**75.370**  
**Ventilation Plan**

Mine Safety and Health Administration  
604 Cheat Road  
Morgantown, West Virginia 26508

The request filed November 30, 2005, to maintain three open crosscuts at the Sago Mine, I.D. No. 46-08791, has been reviewed. The response to providing justification of merely increasing the air quantity 4,500 cfm above the minimum requirements is not adequate justification that ensures the safety of the miners. The request may be considered if sufficient justification is presented, other than for convenience, such as specific conditions on the working section that prevent the stoppings from being maintained to and including the third connecting crosscut outby the faces. Therefore, your request is not being approved.

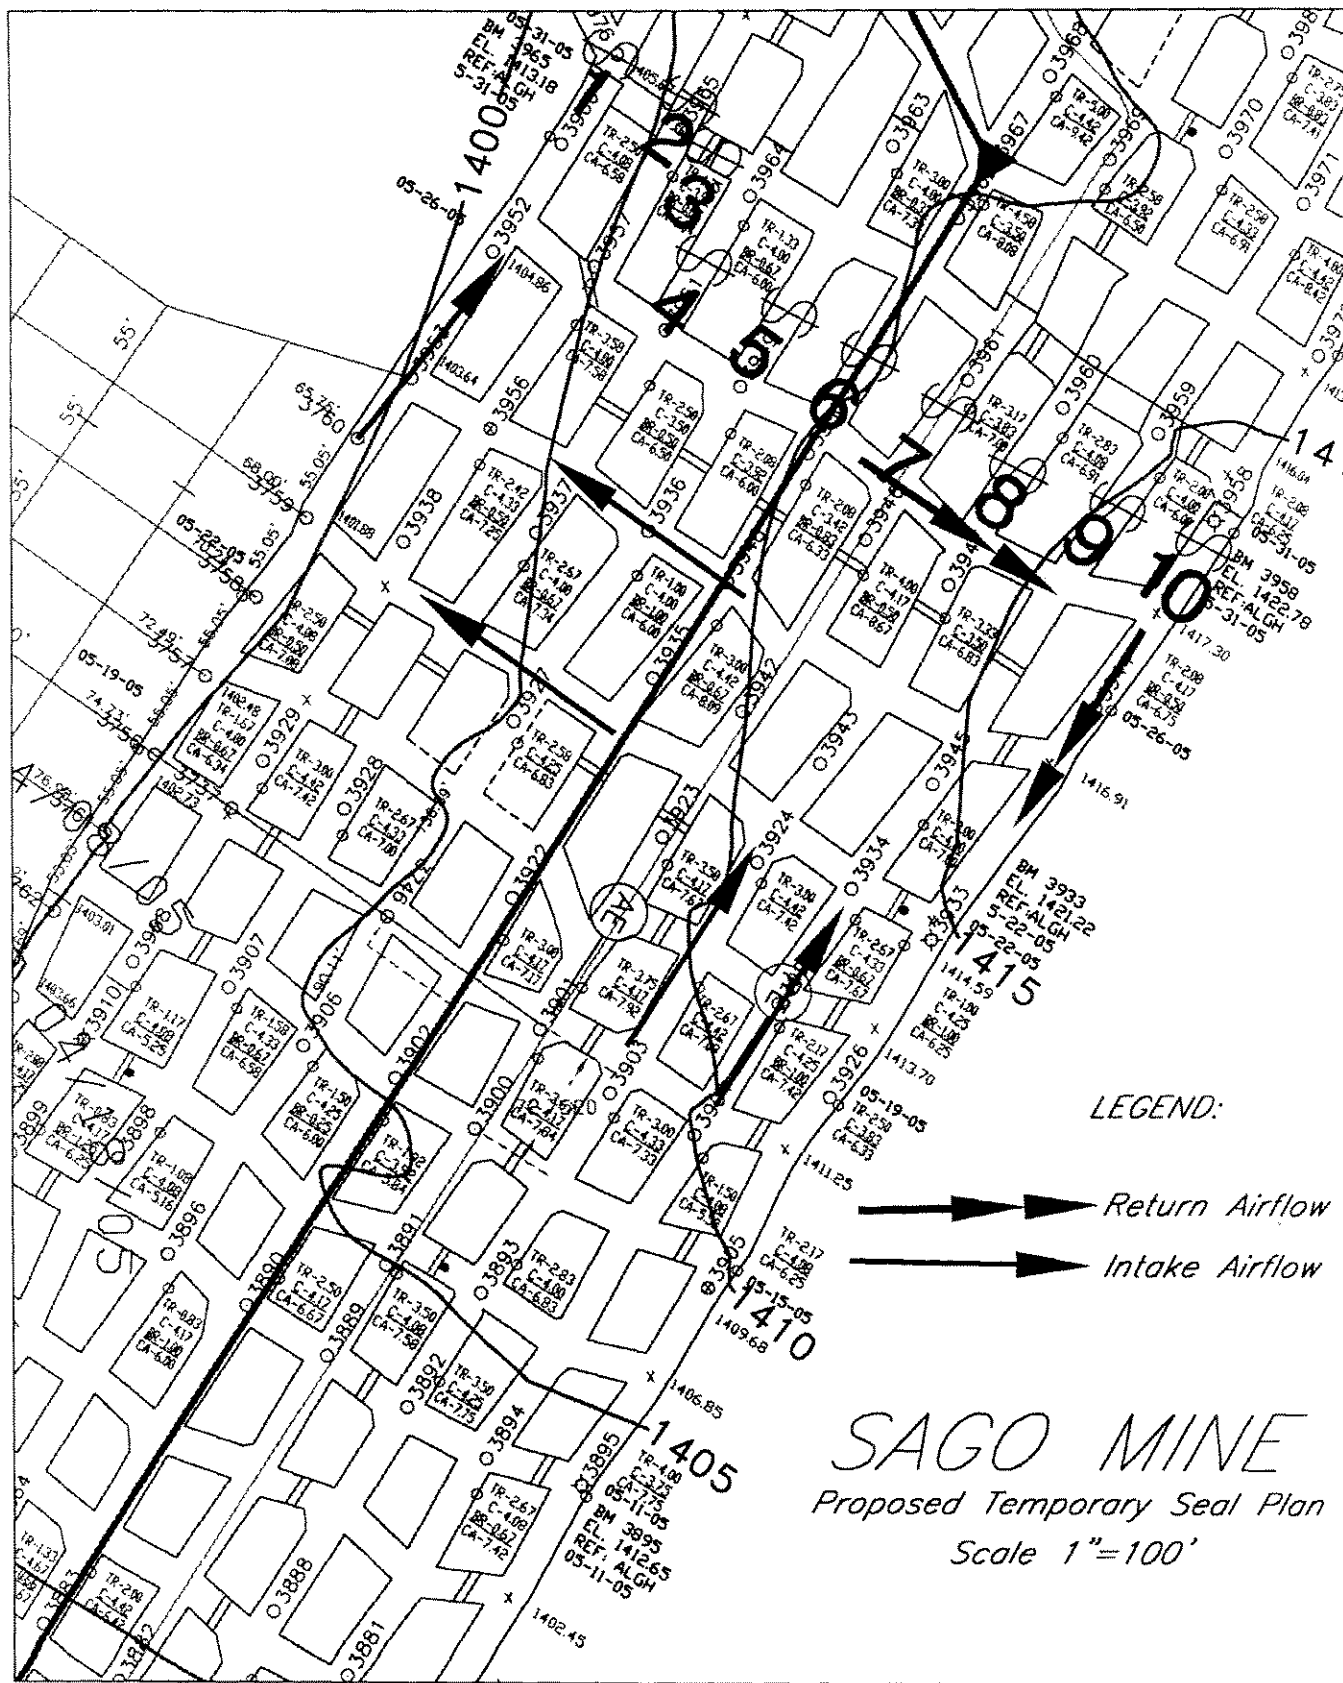
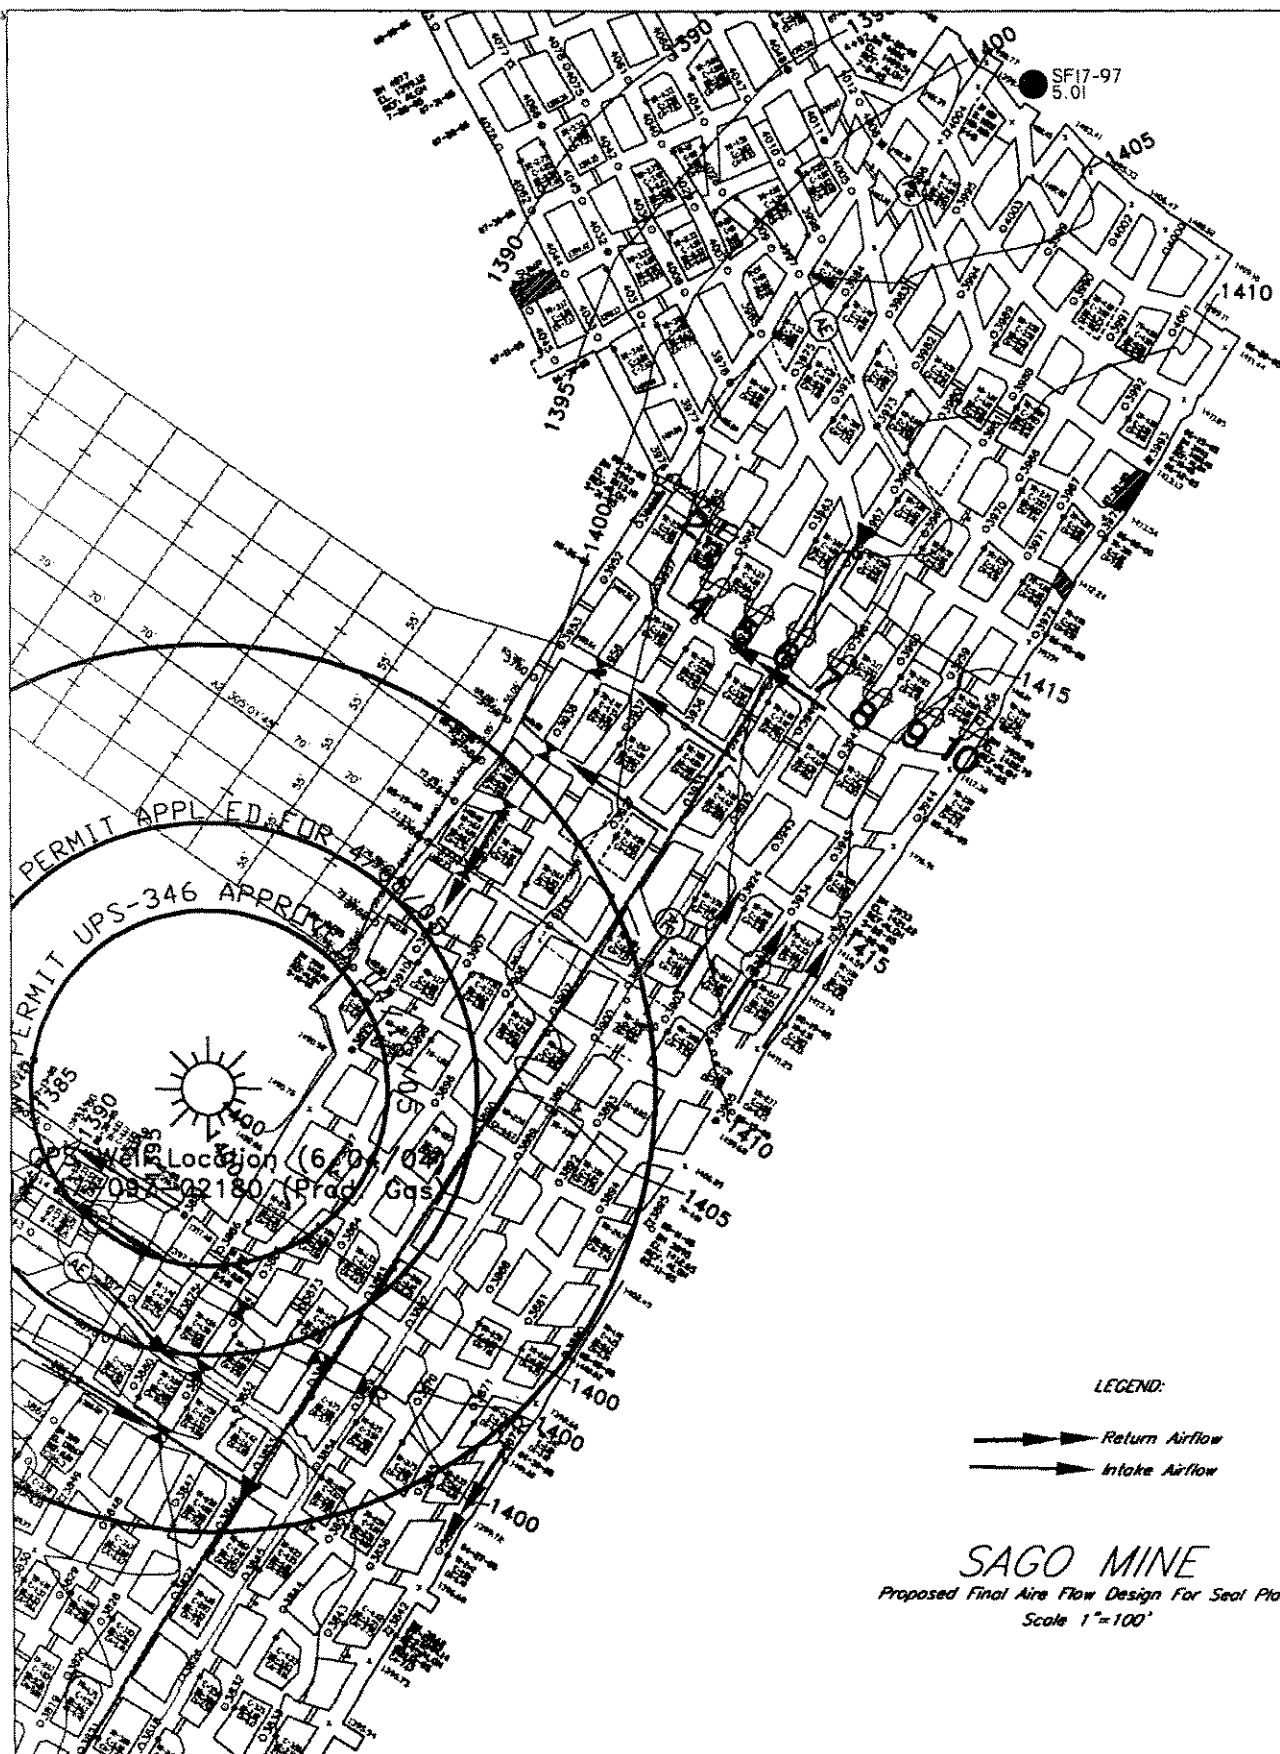
Anker West Virginia Mining Company wishes to seek approval relative to installing nine mine seals across our North-East Mains in our Sago Mine, MSHA ID # 46-08791.

The mine seals being proposed will be constructed across our North East Mains, just inby the area that will be the future location of the 2<sup>nd</sup> Mains Unit. The proposed seals will be constructed across the North East Mains area in such a manner that the No. 2-9 seals will be constructed first, with seal numbers 1 and 10 be constructed simultaneously. It should be noted that for a temporary time frame, (not to exceed a four week period after the construction of said seals), that we will course air from a left-to-right direction, (from the number 1 entry towards the number 9 entry), in order to ventilate these seals; however, once we have constructed the necessary overcasts on the future 2<sup>nd</sup> Left Mains the air flow direction will be switched to a right-to-left direction, (From the number 9 entry towards the number 1 entry). See attached mapping to see air flow direction and ventilation control devices.

The proposed location and sequence of seal construction across North East Mains and the intentional ventilation change filed October 12, 2005, at the Sago Mine, I.D. No. 46-08791, has been reviewed. The request is approved and will be included as a supplement to the mine ventilation map filed pursuant to 30 CFR 75.372.

40" THICK OMEGA BLOCK SEAL

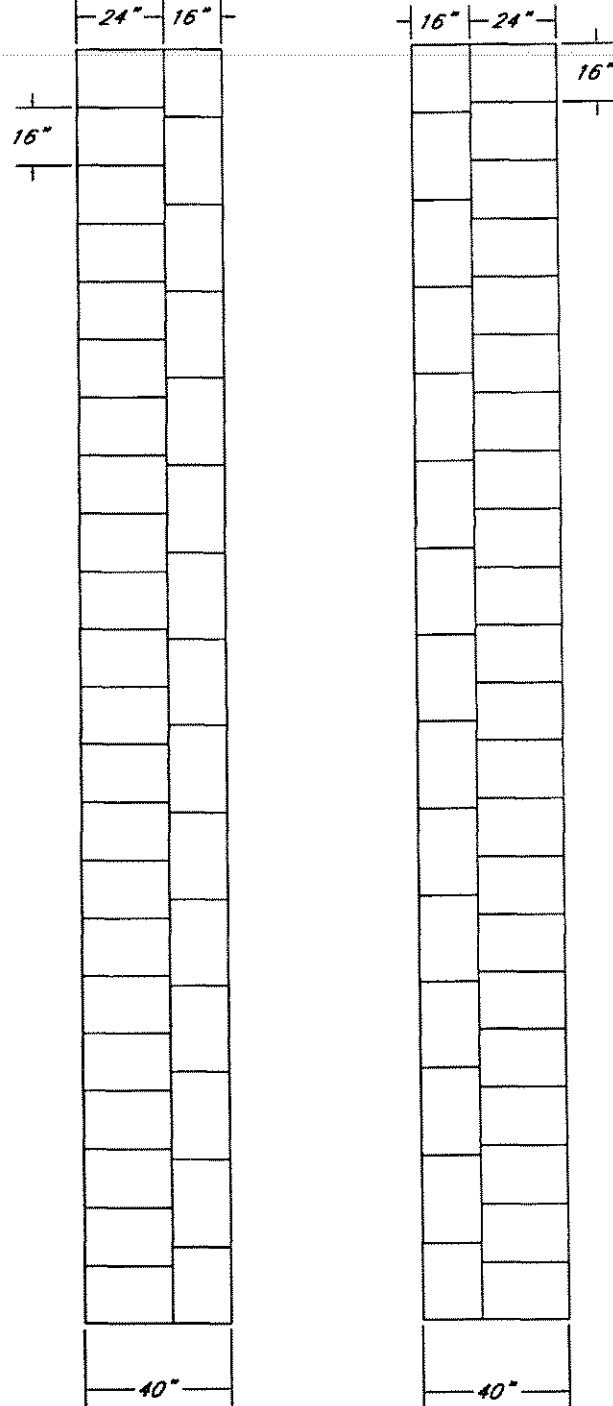
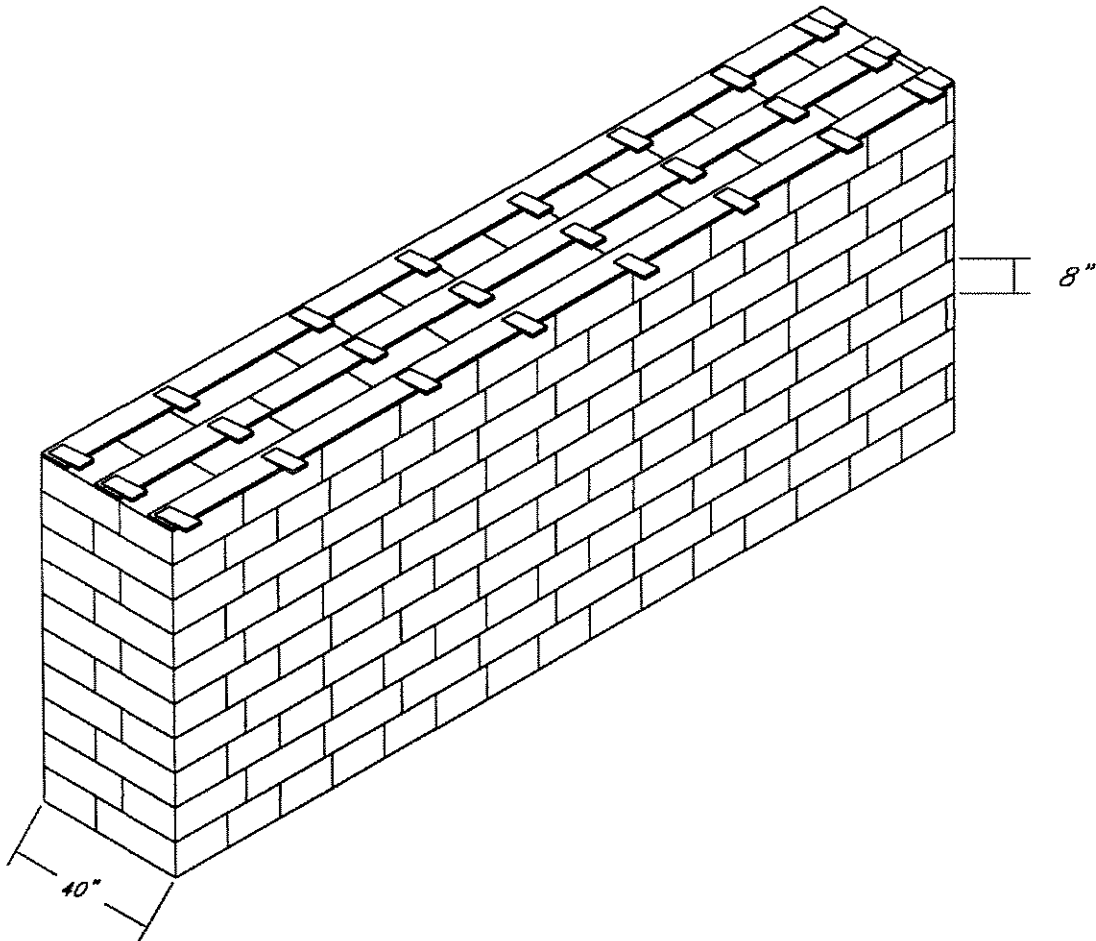
Anker West Virginia Mining Company wishes to add an Omega Concrete Block Seal Method and Plan to our current Ventilation Plan for our Sago Mine, MSHA ID # 46-08791. It should be noted, that at this time, we only wish to add the non-hitched style to our plan. (See attached diagrams).

The request filed October 12, 2005, and revision filed October 19, 2005, to add an alternative method of seal construction to the ventilation plan for the Sago Mine, I.D. No. 46-08791, has been reviewed. The alternative method seal made with nonhitched-style Omega blocks is approved and will be included in your currently approved mine ventilation plan.

TEST AREA  
FOR  
A-PANEL AREA  
SAGO MINE

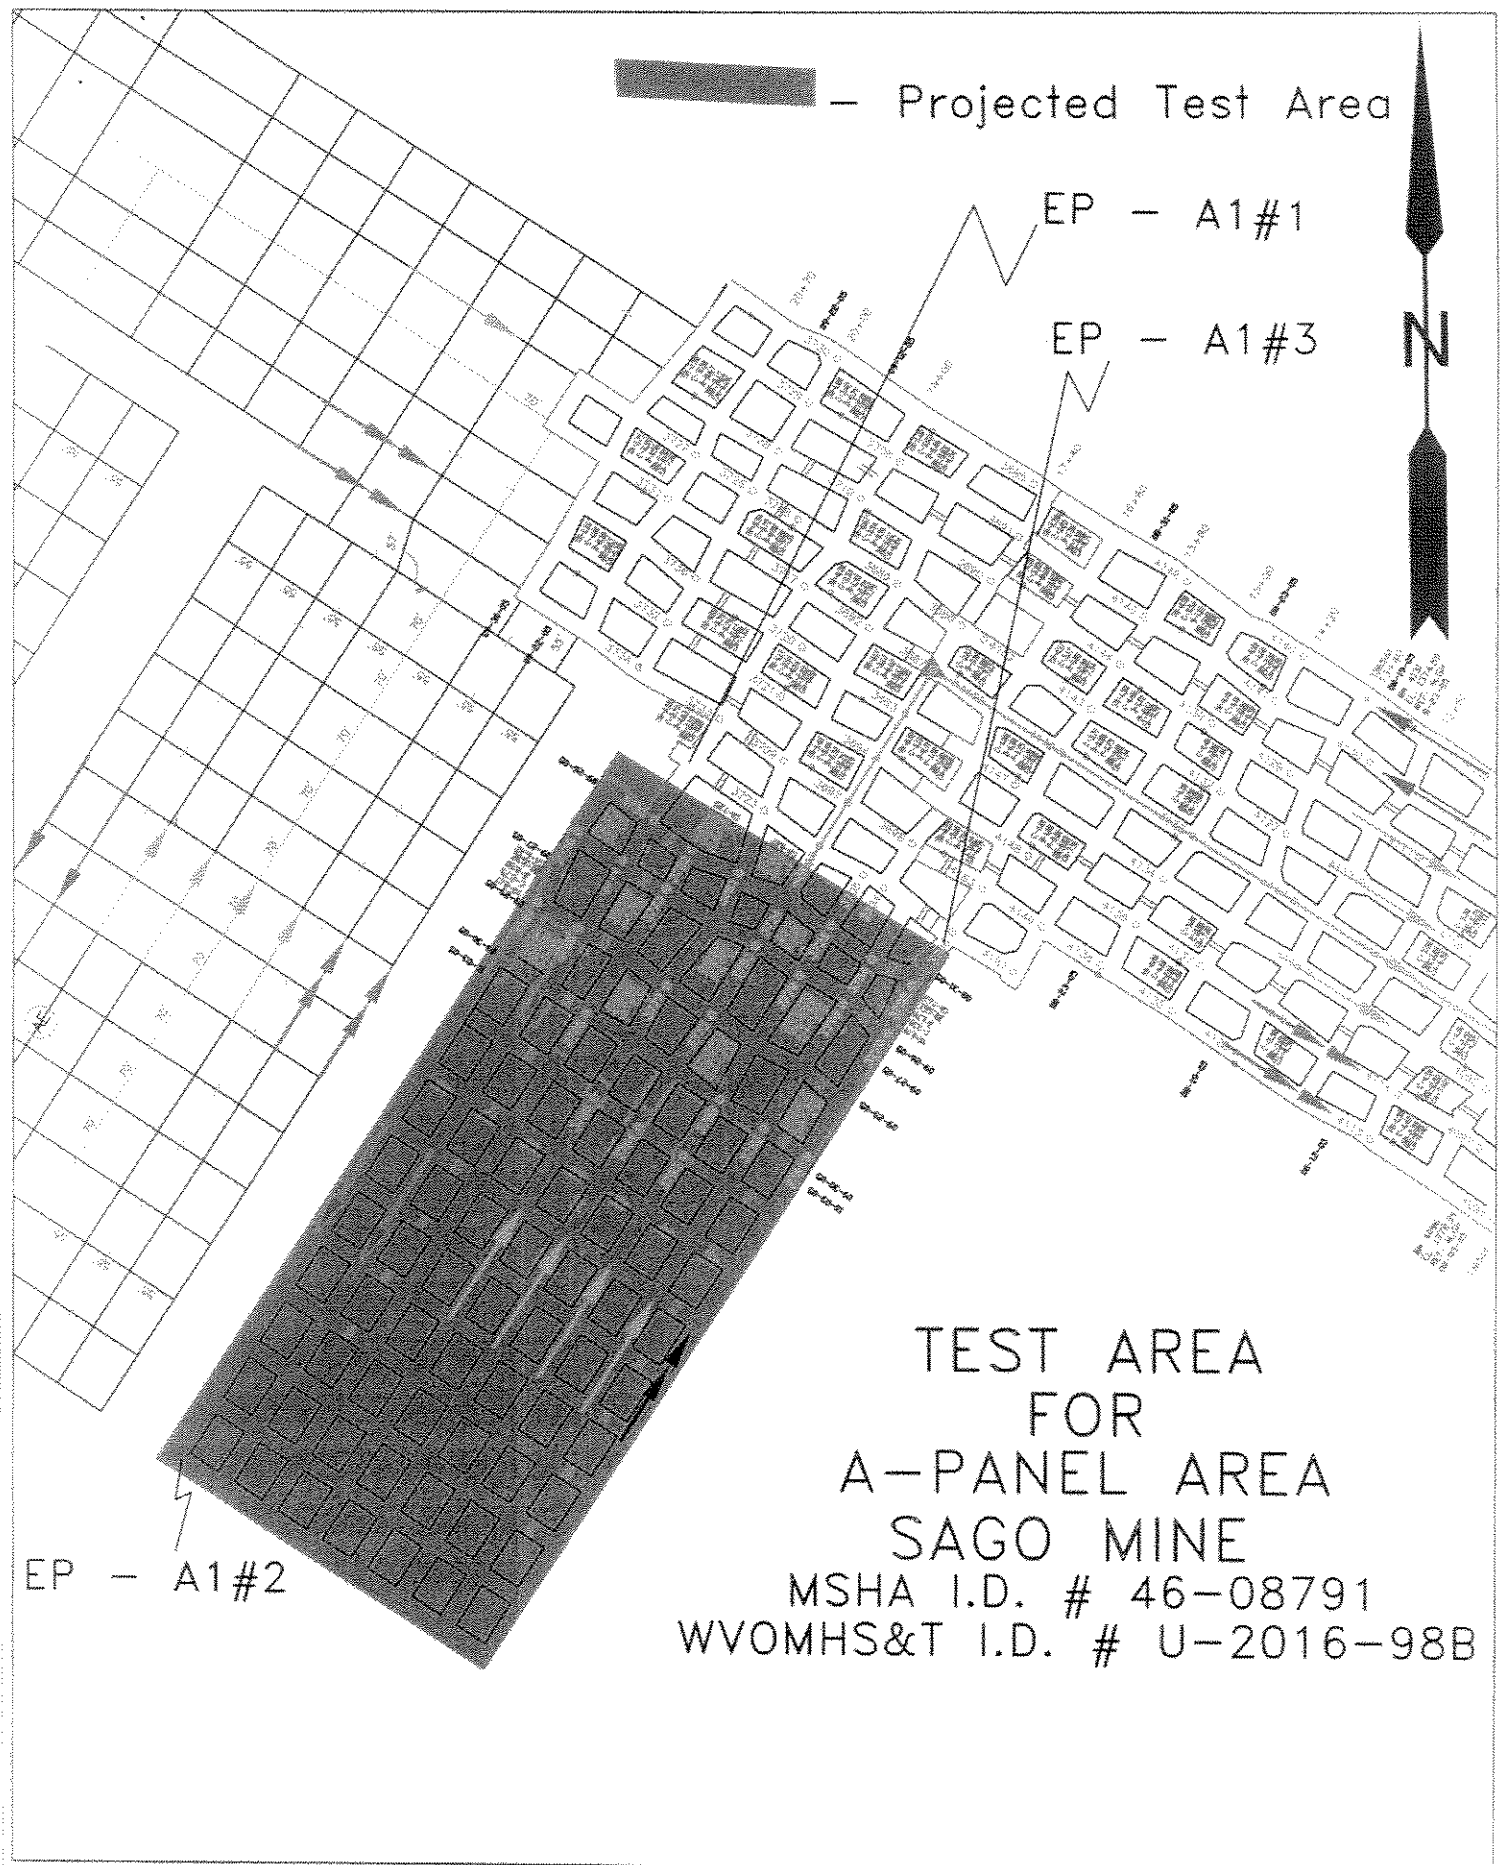
In closing, your prompt review and approval of this request will be greatly appreciated by this department. If you have any questions concerning this correspondence please feel free to contact me at 1-304-471-3442.

The request filed October 17, 2005, for a test area as shown on the accompanying map for the ventilation and evaluation of the worked-out area as a result of mining the lower bench of the Middle Kittanning coal seam in the A-Panel at the Sago Mine, I.D. No. 46-08791, has been reviewed and is approved. This information will be included in your currently approved mine ventilation plan.
